Product Change Notification

Change Notification #: 113318 - 00
Change Title: Intel® Server Pedestal Chassis Hot Swap Drive Kit FUP4X35HSDK
PCN 113318-00, Product Design
Add a bracket and remove the venting holes
Date of Publication: October 17, 2014

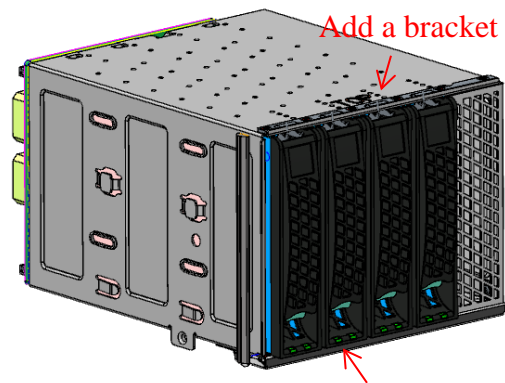
- Add a bracket and remove the venting holes to improve the integration stability. Refer to the following pictures.

Remove the venting holes
